Bulletin 160-P2 and 160-P3 CE Conformance

- Publication 0160-5.28ML dated September, 1999
- Publication 0160-5.29ML dated September, 1999

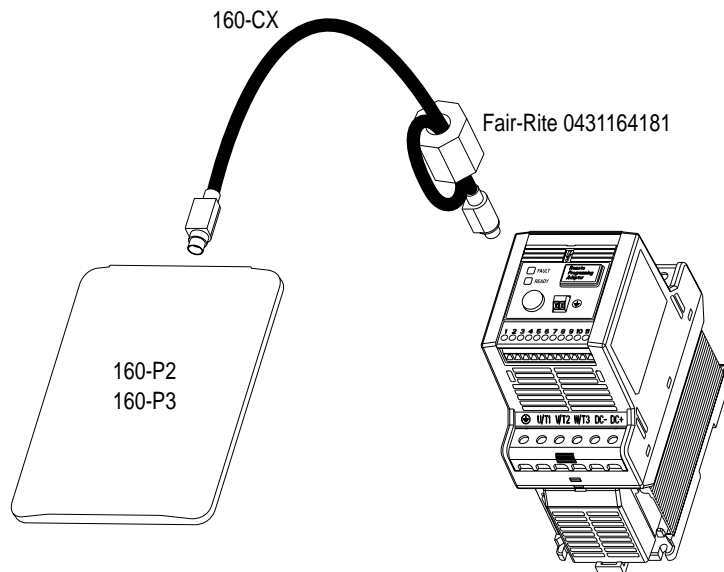
CE Conformance standards require control of radiated emissions (EMI).

Without suppression, 160-CX cables used with 160-P2 (Bulletin 160 SSC™ Remote Keypad Module) and 160-P3 (Bulletin 160 SSC™ CopyCat Keypad Module) will exceed CE standards.

Add a ferrite bead to the 160-CX cables at the drive side of the cable.

Use Fair-Rite part number 0431164181 or equivalent with a complete turn as shown.
